MCP2140 Rev. A Silicon/Data Sheet Errata

The MCP2140 Rev. A parts you have received conform functionally to the MCP2140 device data sheets (DS21790A), with the exception of the anomaly described below.

Clarifications/Corrections to the Data Sheet:

FIGURE 1: CIRCUIT FOR AN INTEGRATED OPTICAL TRANSCEIVER

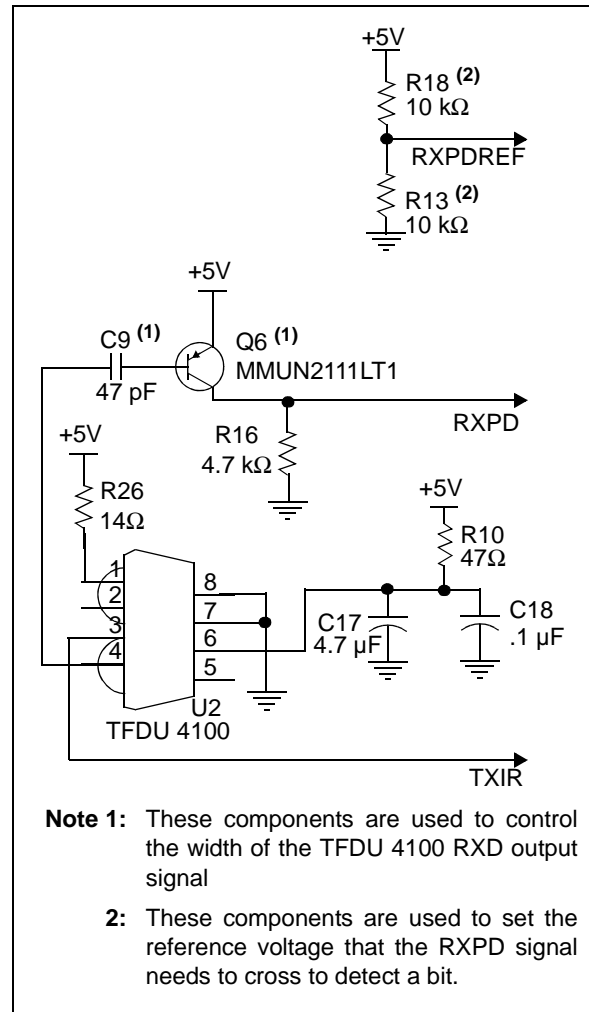
- Figure 2-12 should be corrected to the circuit shown in Figure 1.
